MEMORANDUM

SUBJECT: Public hearing and consideration of an application for a

Landmark Alteration Certificate to construct a 1,359 sq. ft. addition to a contributing house and to construct a 440 sq. ft. two-car garage at 735 Mapleton Ave. in the Mapleton Hill Historic District, per section 9-11-18 of the Boulder Revised

Code 1981 (HIS2014-00192).

Figure 7. July 2nd, 2014 (left) and Proposed Site Plans (right).

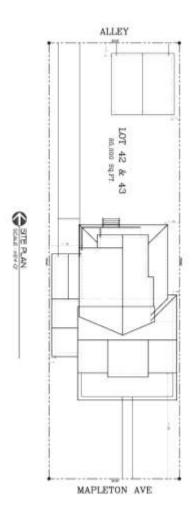
With the proposed addition, the proposed floor area of the house is calculated to be approximately 3,253 sq. ft. with the estimated lot coverage estimated at 2,071 sq. ft. on the 8,500 sq. ft. lot. The application states with the proposed garage, the total floor area (FAR) for the proposal to be 3,693 sq. ft. where the maximum floor area for this property is 3,800 sq. ft. Preliminary code review indicates that no solar shadow analysis has been done and that the FAR and lot coverage are close to the maximum allowed in the Low Density Residential (RL-1) area.

.4	Preserve a backyard area between the house and the garage, maintaining the general proportion of built mass to open space found within the area. See Guideline 2.1.1.	Addition and proposed new garage will encroach upon openness of existing yard. With garage and addition property will approach allowable FAR and be higher than the historic condition for similar properties in the streetscape.	Maybe

- b. Reduces the overall amount of built area to open space by reducing the size of the garage and/or addition;
 - c. Retains a greater portion of the north (rear) wall of the historic house and create a more defined connection between the historic house and new addition;

Figure 15. West and North Elevations of proposed garage

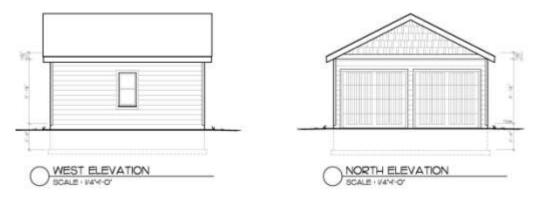
New garages and accessory buildings should generally be located at the rear of the lot, respecting the traditional relationship of such buildings to the primary structure and the site.	The proposed garage will take access from the alley.	Yes
Maintain adequate spacing between accessory buildings so alleys do not evolve into tunnel-like passageways.	Proposed two-car garage will have 22' wide face on alley and will obscure some of the visibility into the yard from the alley.	Maybe
Preserve a backyard area between the house and the accessory buildings, maintaining the general proportion of built mass to open space found within the area.	Construction of proposed 440 sq. ft. garage with large rear addition to house will affect general proportion of built mass to open space of the property or streetscape. Consider reducing to one-car garage to lessen amount of built area to open space on the property.	Maybe

New accessory buildings should take design cues from the primary building on the property, but be subordinate to it in terms of size and massing.	Pitch of proposed garage roof similar to that of existing attached garage. Given the existence of one-car garage on property, consider reducing two-car to	Maybe
New garages for single-family residences should generally be one story tall and shelter no more than two cars. In some cases, a two- car garage may be inappropriate.	Proposed two-car garage is one-story in height - consider reducing to one-car garage. Review at Ldrc.	Maybe
Roof form and pitch should be complementary to the primary structure.	Roof form is complementary to the existing attached garage at the rear of the house.	Yes
Mate	erials and Detailing	
Accessory structures should be simpler in design and detail than the primary building.	As shown, garage is simpler than main house in design, material, and detailing.	Yes

Materials for new garages and accessory structures should be compatible with those found on the primary structure and in the district. Vinyl siding and prefabricated structures are inappropriate.	Proposed materials (wood siding, windows, and doors) will be compatible with character of historic district. Consider using not using only clapboard siding (see 2.3.3 above). Resolve at Ldrc.	Maybe
Windows, like all elements of accessory structures, should be simpler in detailing and smaller in scale than similar elements on primary structures.	Proposed design appears compatible in terms of window type, size and detailing with similar elements on the primary building.	Yes
If consistent with the architectural style and appropriately sized and located, dormers	N/A	N/A
	generally be located at the rear of the lot, respecting the traditional relationship of such buildings to the primary structure and the site. Maintain adequate spacing between accessory buildings so alleys do not evolve into tunnel-like passageways. Preserve a backyard area between the house and the accessory buildings, maintaining the general proportion of built mass to open space found within the area. New accessory buildings should take design cues from the primary building on the property, but be subordinate to it in terms of size and massing. New garages for single-family residences should generally be one story tall and shelter no more than two cars. In some cases, a two-car garage may be inappropriate. Roof form and pitch should be complementary to the primary structure. Materials for new garages and accessory structures should be compatible with those found on the primary structure and in the district. Vinyl siding and prefabricated structures are inappropriate. Windows, like all elements of accessory structures, should be simpler in detailing and smaller in scale than similar elements on primary structures. If consistent with the architectural style and	generally be located at the rear of the lot, respecting the traditional relationship of such buildings to the primary structure and the site. Maintain adequate spacing between accessory buildings so alleys do not evolve into tunnel-like passageways. Preserve a backyard area between the house and the accessory buildings, maintaining the general proportion of built mass to open space found within the area. Preserve a backyard area between the house and the accessory buildings, maintaining the general proportion of built mass to open space found within the area. Construction of proposed 440 sq. ft. garage will large rear addition to house will affect general proportion of built mass to open space of the property, but be subordinate to it in terms of size and massing. New accessory buildings should take design cues from the primary building on the property, but be subordinate to it in terms of size and massing. New garages for single-family residences should generally be one story tall and shelter no more than two cars. In some cases, a two-car garage may be inappropriate. Roof form and pitch should be complementary to the primary structure. Materials for new garages and accessory structures should be compatible with those found on the primary structure and in the district. Vinyl siding and prefabricated structures are inappropriate. Windows, like all elements of accessory structures, should be simpler in detailing and smaller in scale than similar elements on primary structures. Proposed design appears compatible in terms of window type, size and detailing with similar elements on the primary building. Male property. Mass and Scale Pitch of proposed garage will take access from the alley. Construction of proposed 440 sq. ft. garage with large rear addition to house will affect general proportion of built mass to open space of the property one-car garage to lessen amount of built area to open space on the property, consider reducing two-car to one-car garage. Review at Ldrc. Proposed two-car garage s

- d. Further develops a visual continuity between the existing house by simplifying form, fenestration, and refining materiality; and
 - e. Increases the distance between the existing garage and the west wall of the addition to allow for greater protection of the historic building.

Figure 16: South and East Elevations of proposed garage.

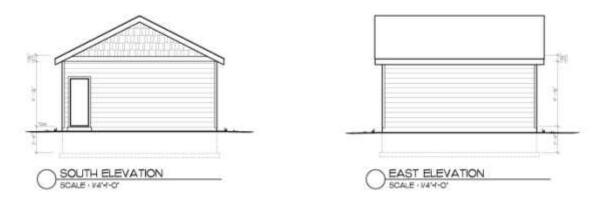
may be an appropriate way to increase storage space in garages.		
.12	Garage doors should be consistent with the historic scale and materials of traditional accessory structures. Wood is the most appropriate material and two smaller doors may be more appropriate than one large door.	Garage doors appear to be consistent in terms of scale and materials. Review final details at Ldrc.	Maybe
.13	It is inappropriate to introduce features or details to a garage or an accessory building in an attempt to create a false historical appearance.	Proposed design does not attempt to recreate a false historic appearance.	Yes
.14	Carports are inappropriate in districts where their form has no historic precedent.	Carport not proposed.	N/A
